ANN ARBOR HISTORIC DISTRICT COMMISSION

Staff Report

ADDRESS: 435 S First Street, Application Number HDC15-226

REPORT DATE: December 10, 2015

EAST
3/16" = 1'-0"

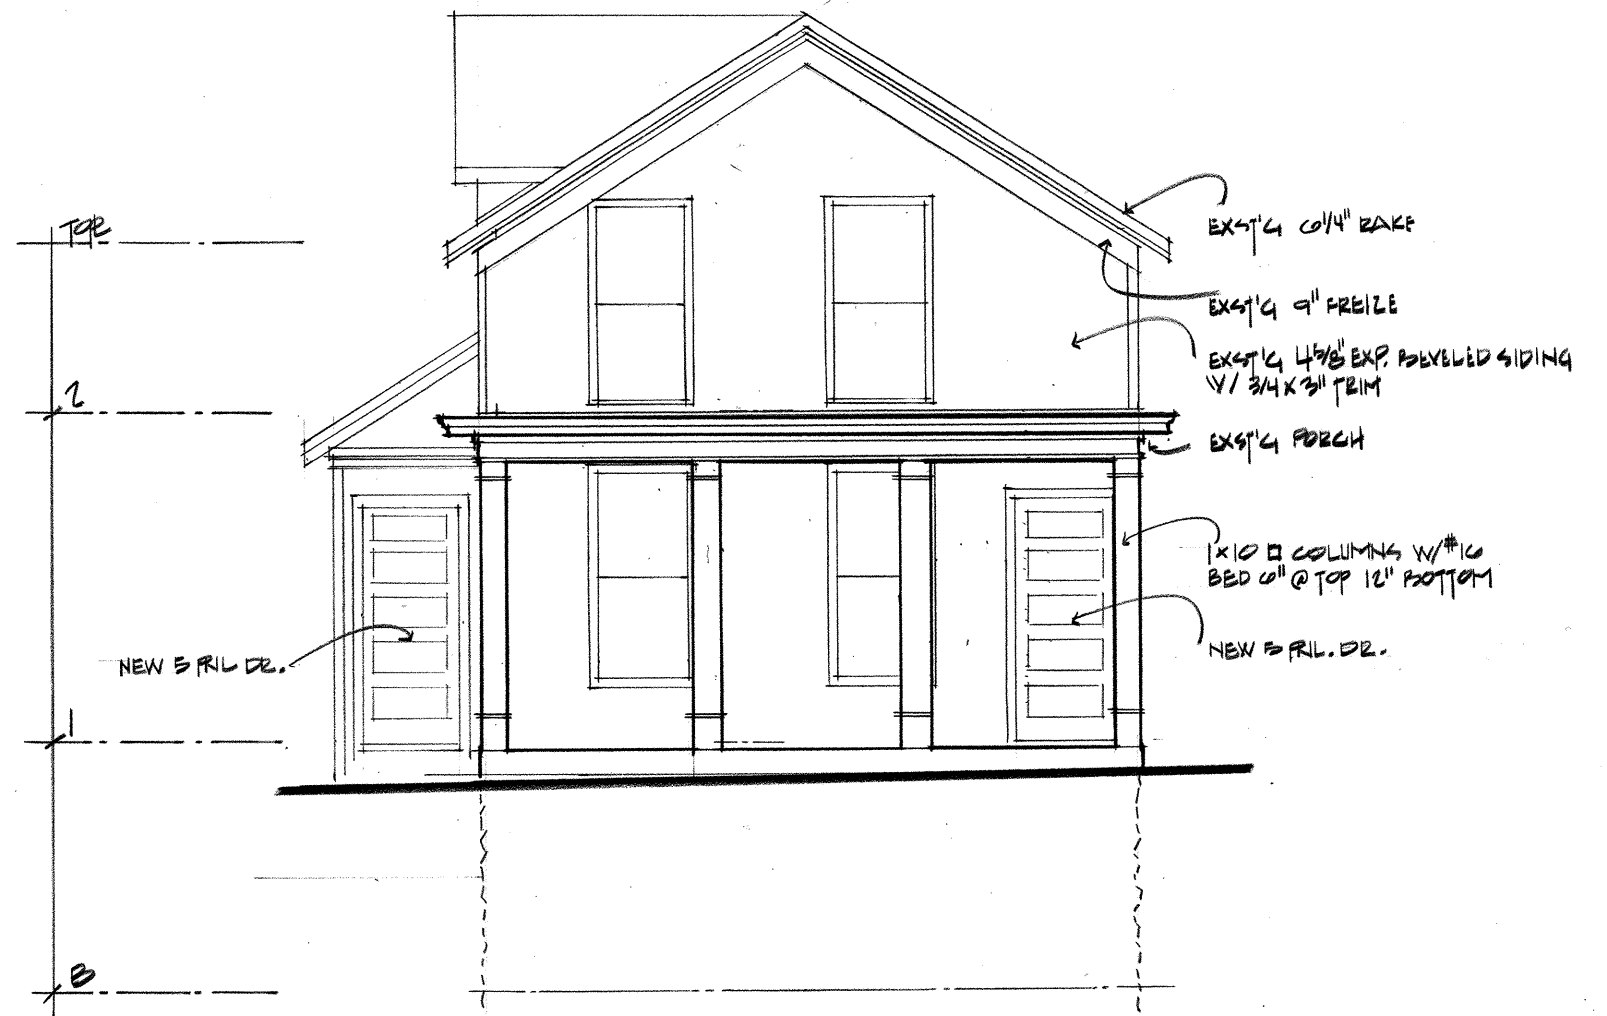
The rear (east) elevation of the house currently contains three non-original double-hung windows on the main floor, and two windows and a door opening into the basement. Per Sanborn maps, the basement level has been altered (the door used to be on the other side). Staff's opinion is that taken together, this elevation's remaining character-defining features are limited, and would not preclude an appropriate addition.

NORTH

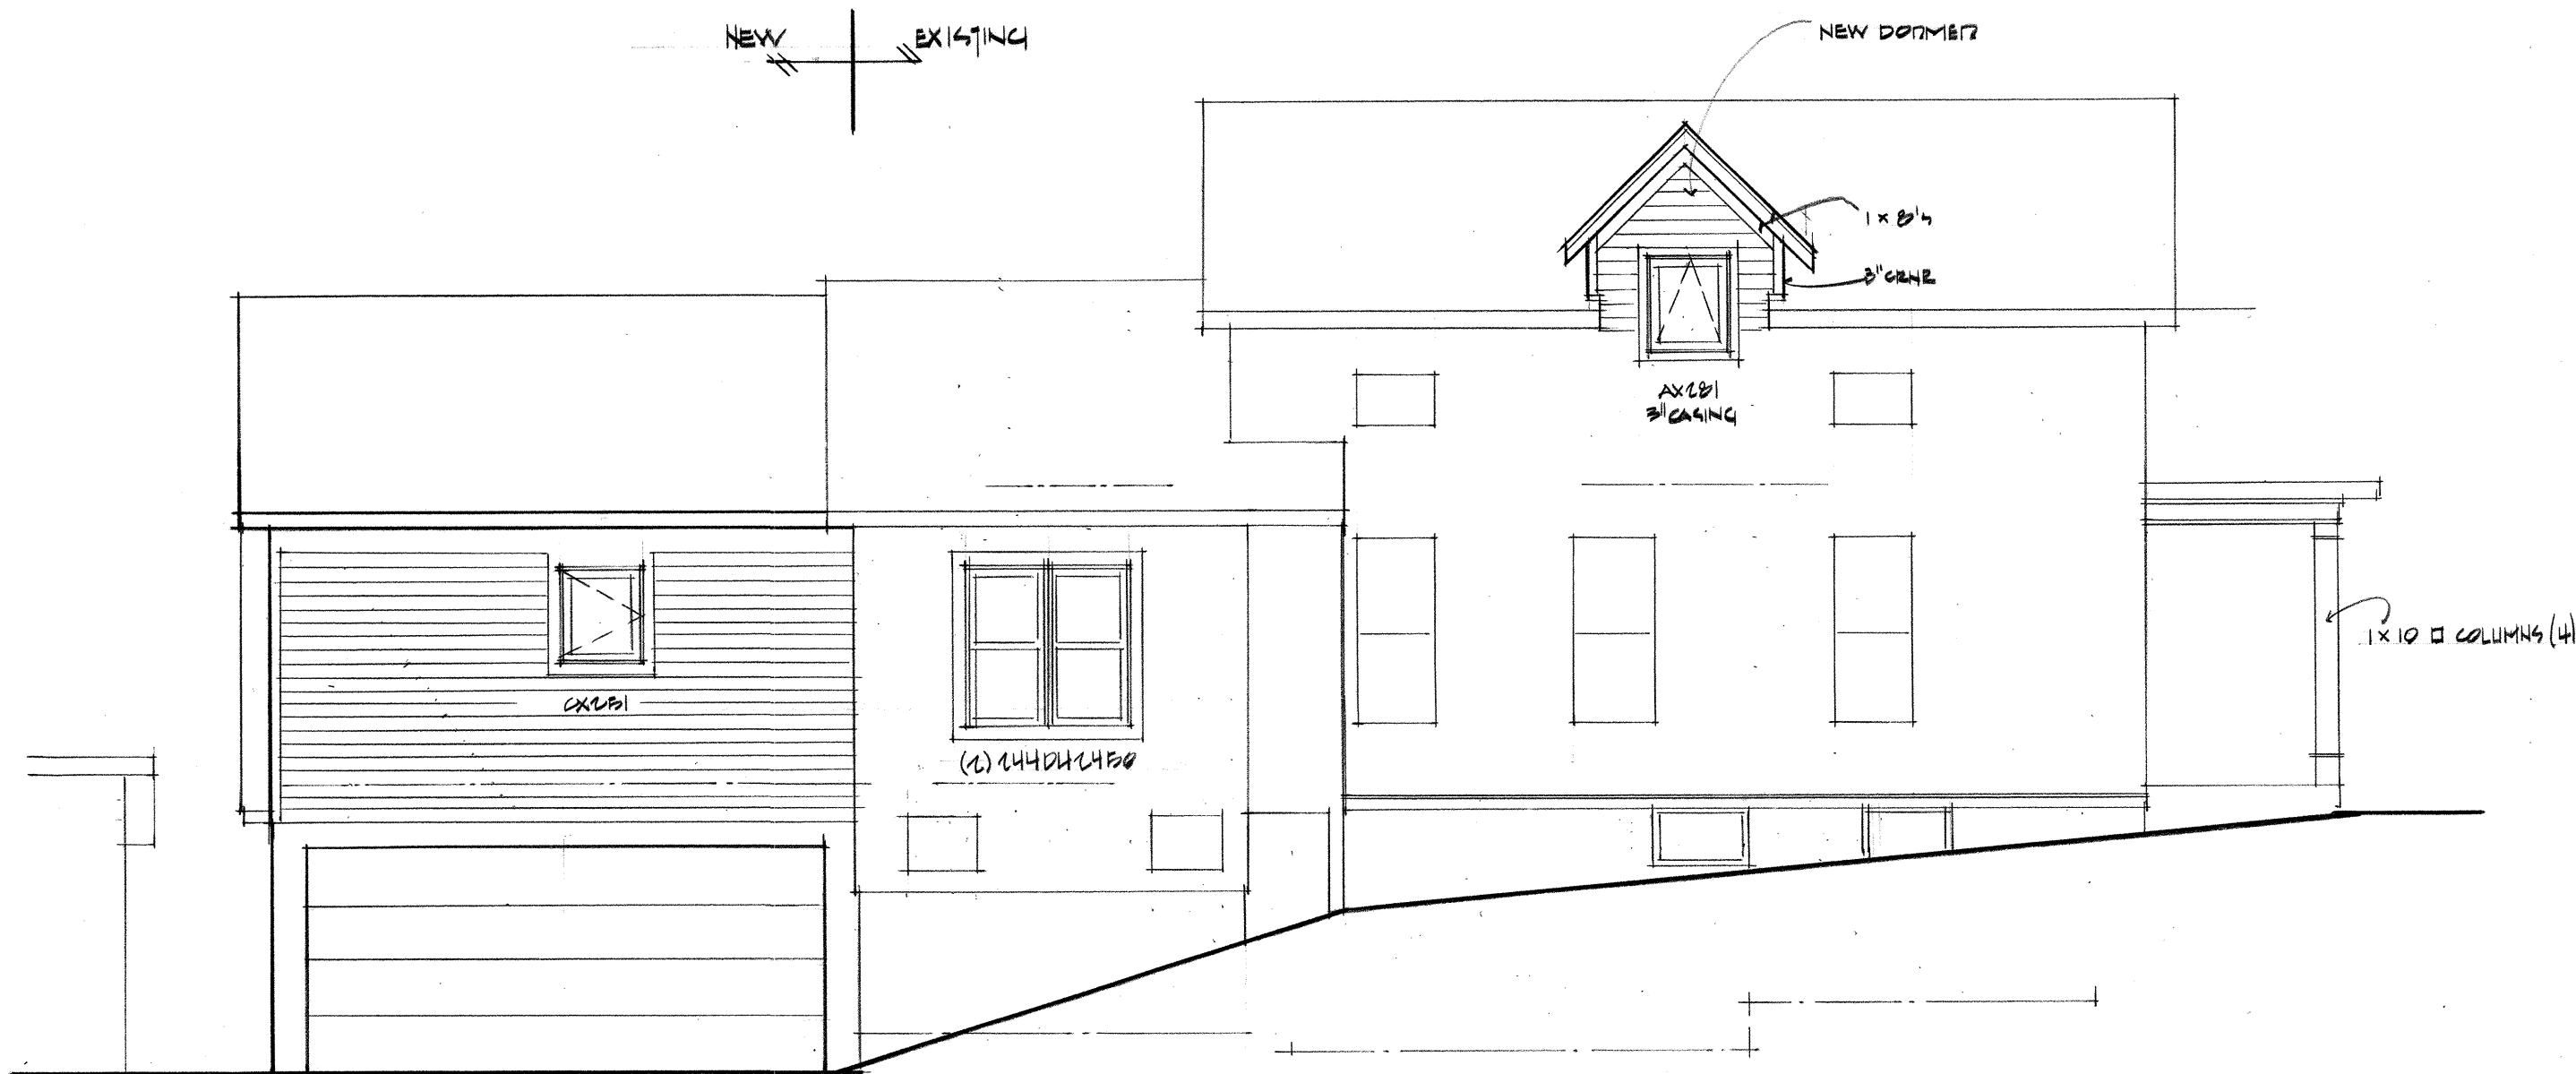
4. Two windows are proposed to be added to the existing rear wing on the north elevation. There are currently no windows on this wall. The proposed pair of double-hung, vinyl-clad wood Andersen 200 series windows will be the only paired windows on the house and are shorter than the other first-floor windows. Also proposed on the north elevation is a 5' wide wall dormer to provide headroom in the upstairs bathroom.
